Appendix D

AUSGRID CORRESPONDENCE

Design Information - Site Specific Terms and Conditions

Ausgrid's Response to a Proposed Design Scope submission received 20.12.17.

3.1.1. High Voltage Proposal

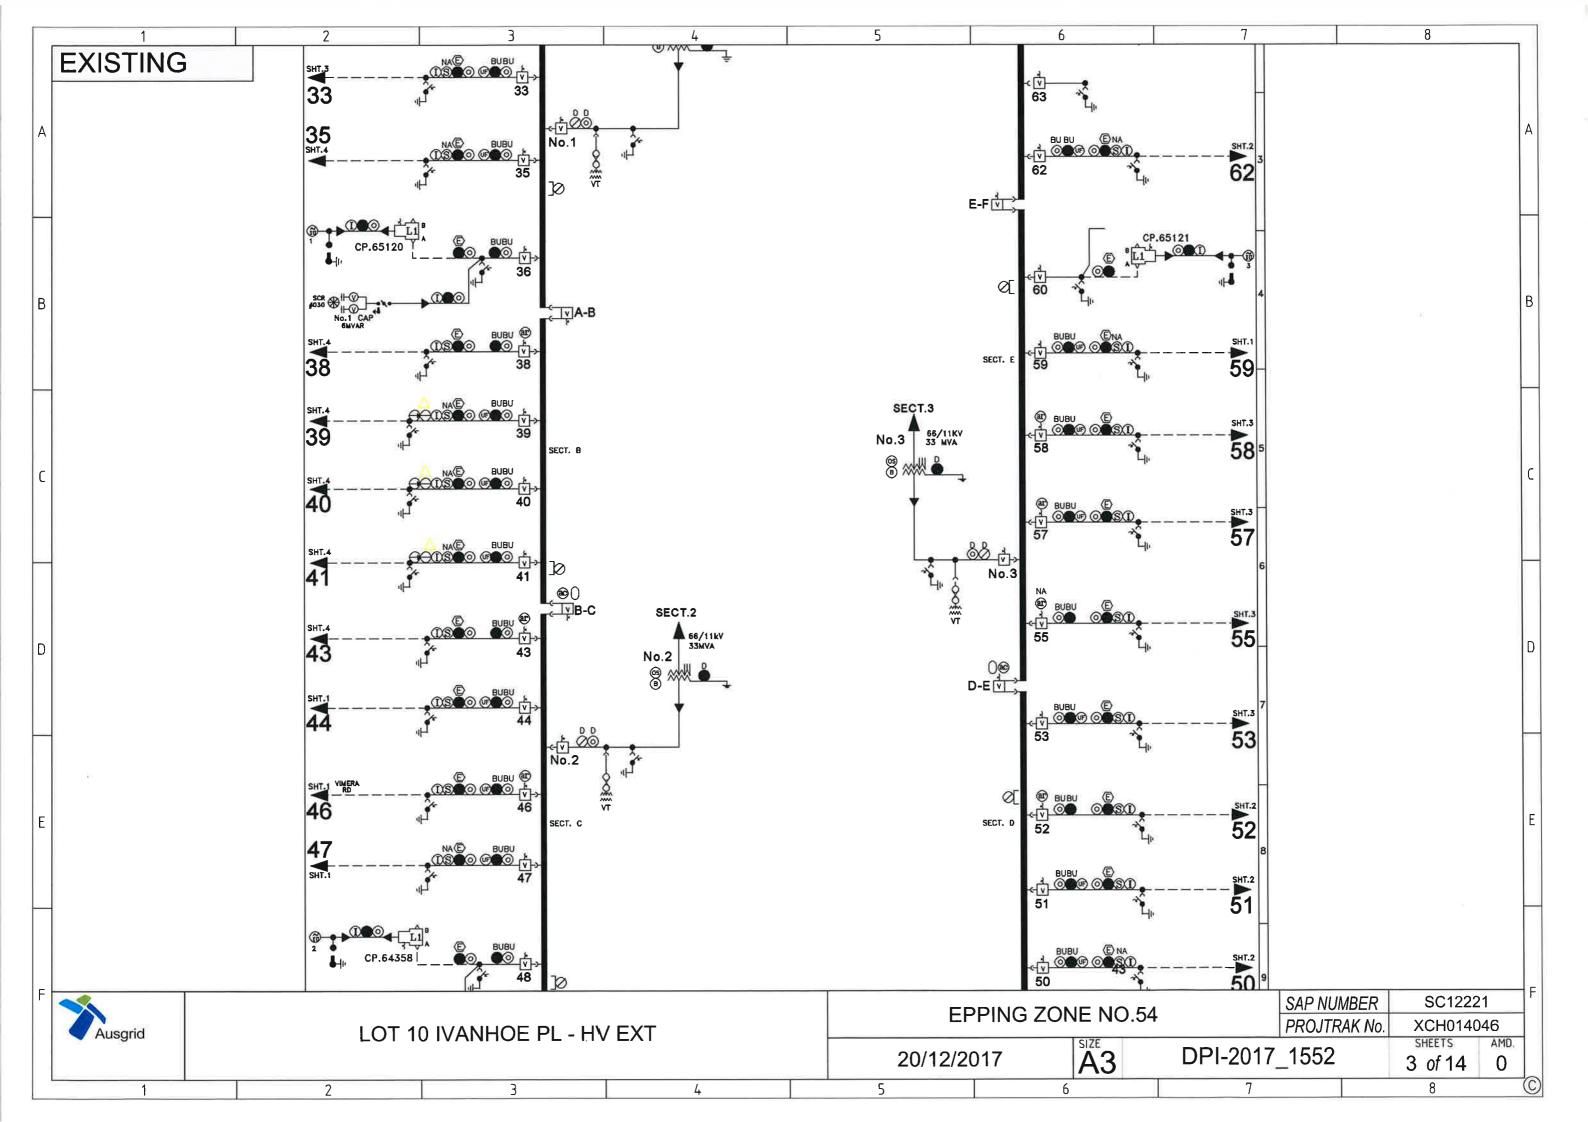
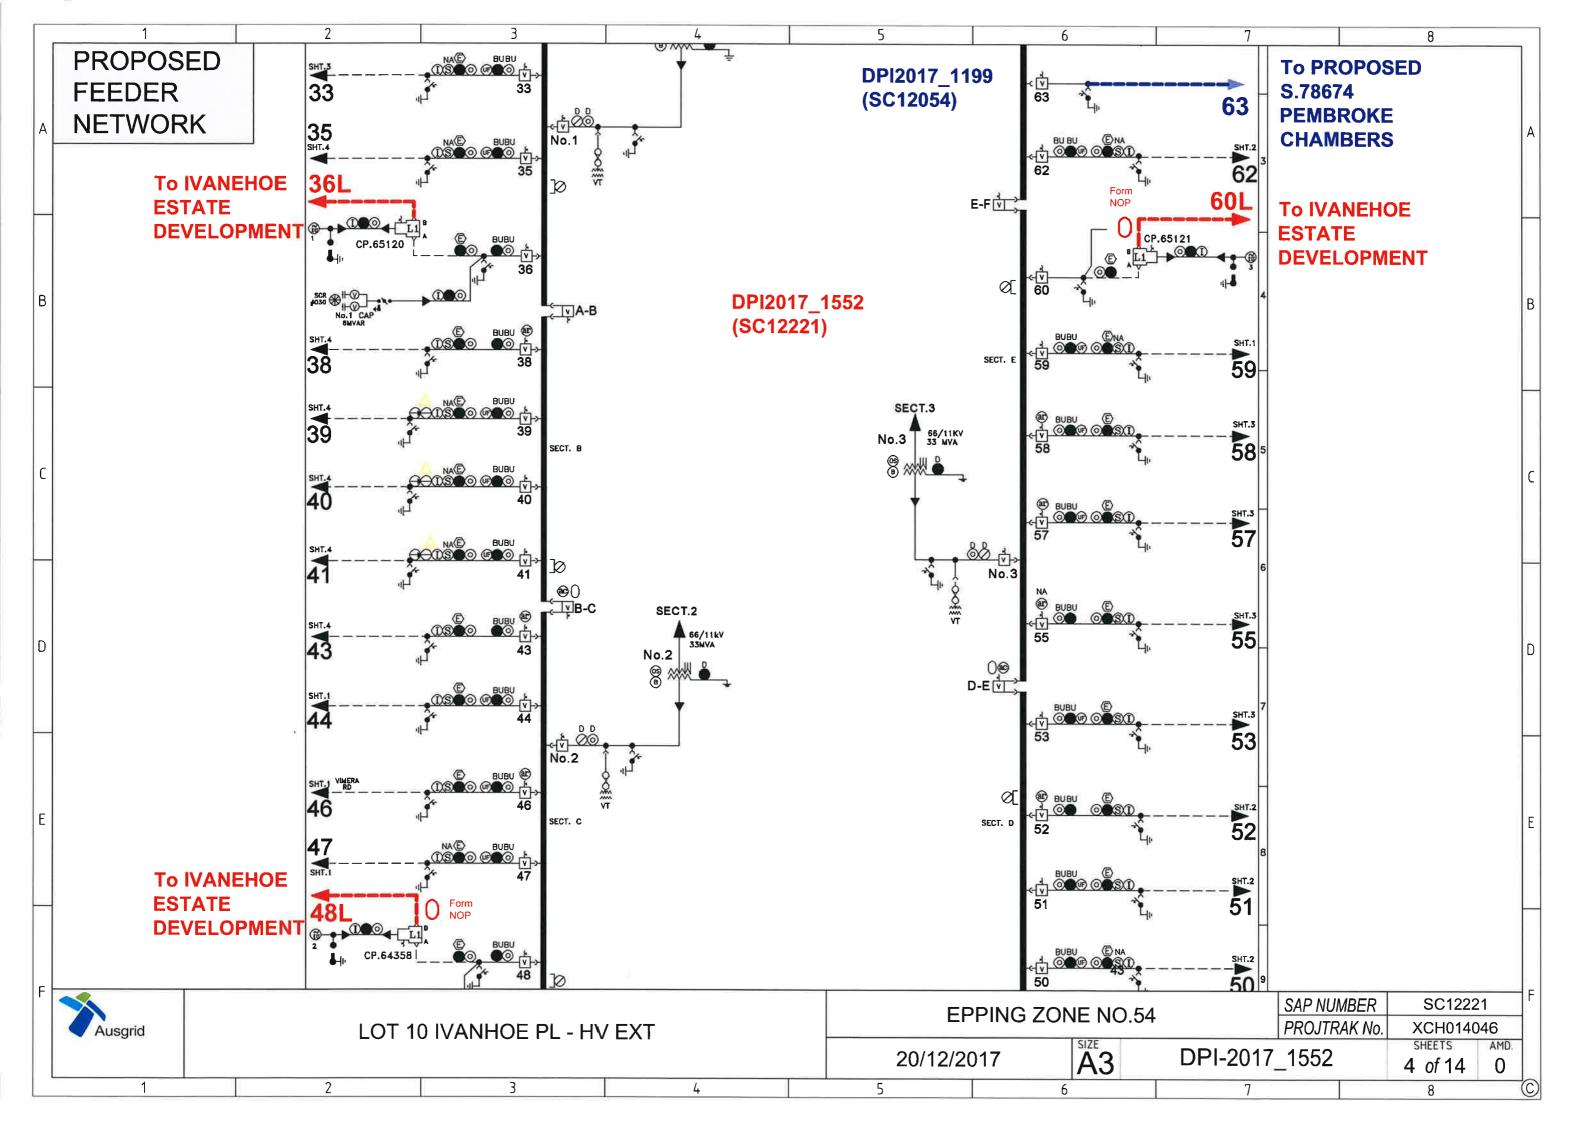
- As per the attached proposed HV feeder network diagram, the proposed length of the HV feeder cables has altered from what was originally stated in the PDS and may exceed 2.62 km.
- Use 500mm² AL3 or 300mm² Cu Triplex cable (or Equivalent). The cables used must be designed to withstand a continuous rating of 350A (HV).
- Any future substations to connect to the proposed HV feeders must be equipped with DM&C (monitoring and control)
 devices prior to commissioning.

3.2. Conduits

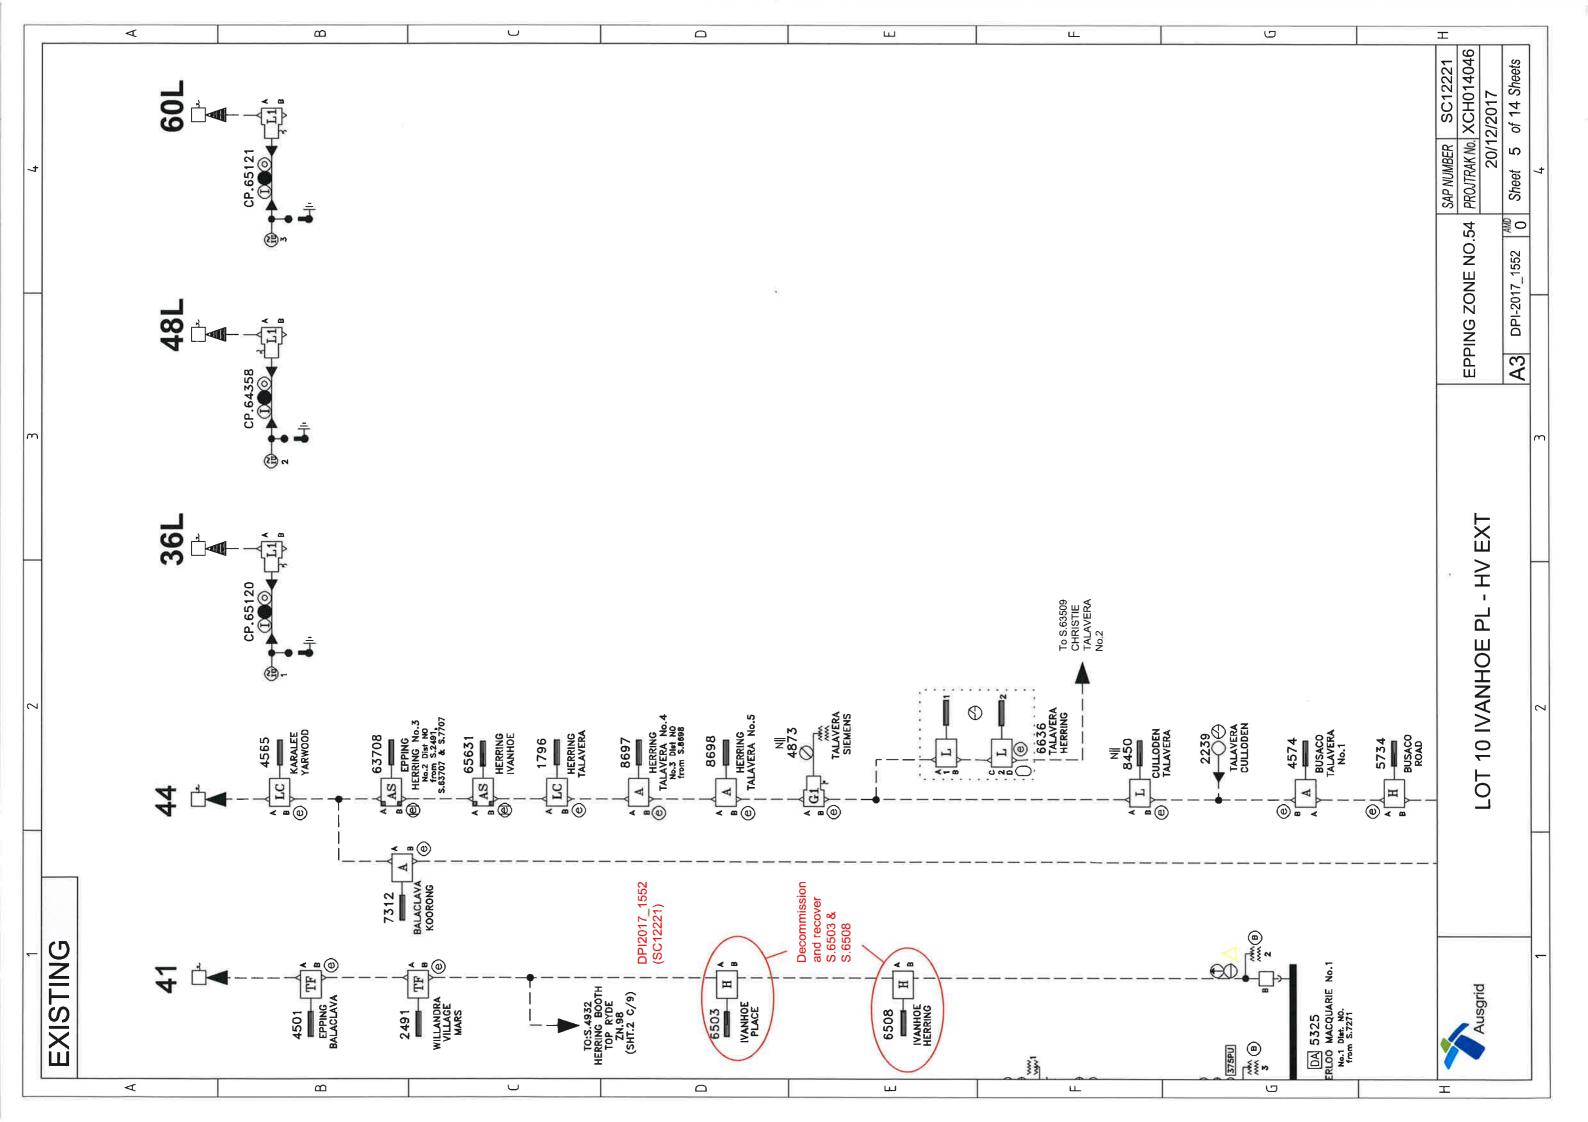
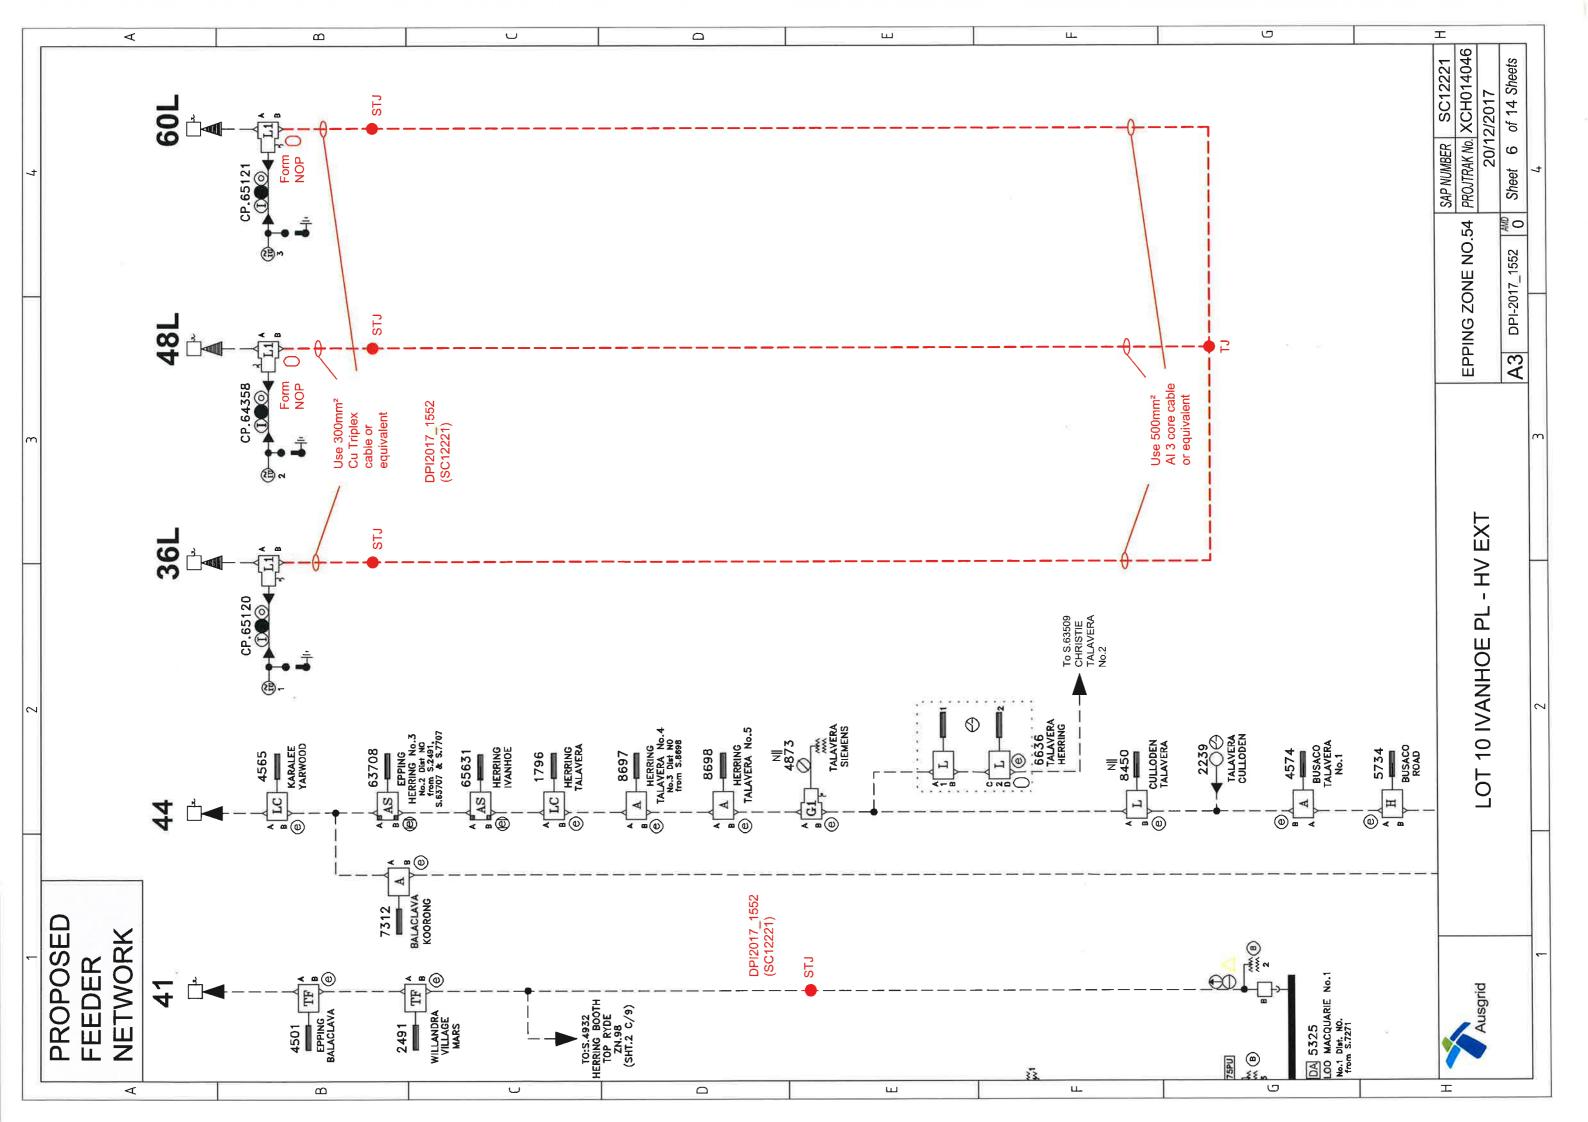
- Where trenching install a minimum of one 150mm spare conduit per every HV feeder cable component
- one (1) spare 63mm conduit (for future optic fibre pilot cable use), is to be installed in association with all 11kV cable trenches.
